## **The spur in HIFI band 1a and impact on observations of H<sub>2</sub>O**

**Fig 1:** Receiver noise temperatures in band 1a for the H and V polarisations, in HSpot 5.1 (old value) and HSpot 5.2 (new values)

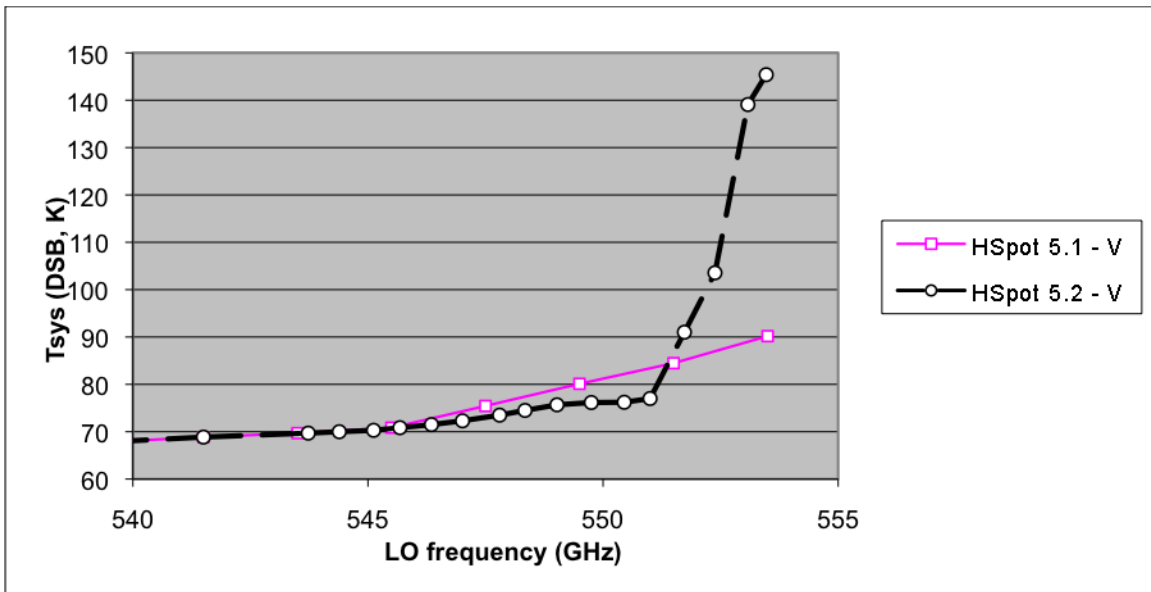
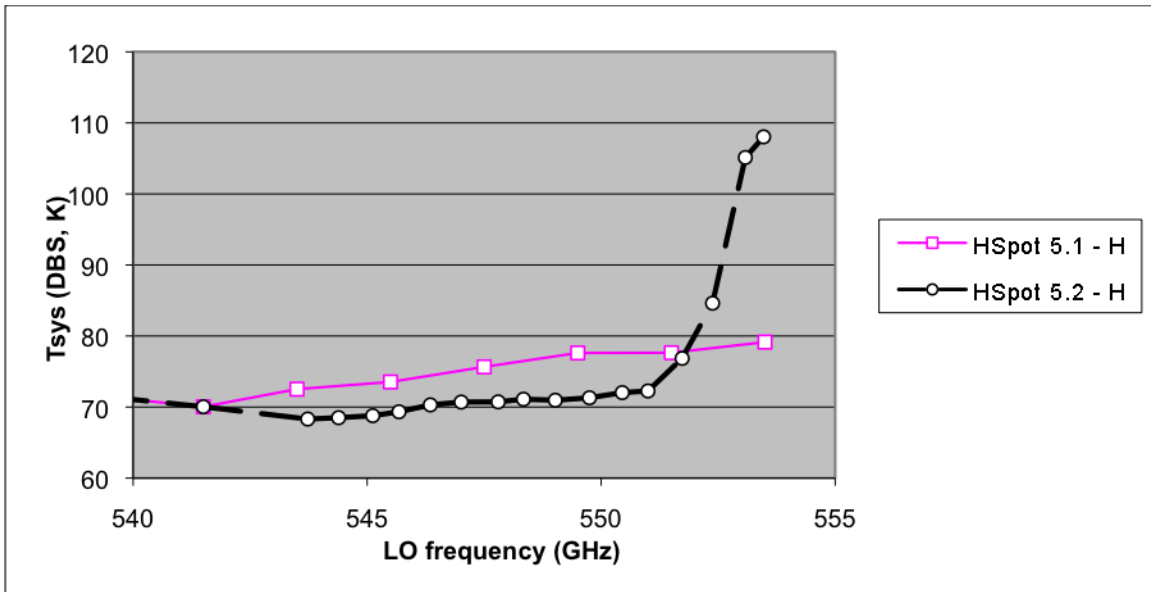
We also invite users who moved to band 1b in order to observe this line to reconsider using band 1a if it makes sense for their program. When doing this, users should be aware that the noise temperature in band 1a has slightly changed in the upper frequency range, as a consequence of the spur removal (this is illustrated in Fig. 1 below). The sensitivity is better or similar than that in band 1b for LO frequencies up to 551.9 GHz. Above this frequency, the time penalty in using band 1a rather than band 1b will depend on the requested noise level (typically, there is no significant difference down to noise rms of some tens of mK).
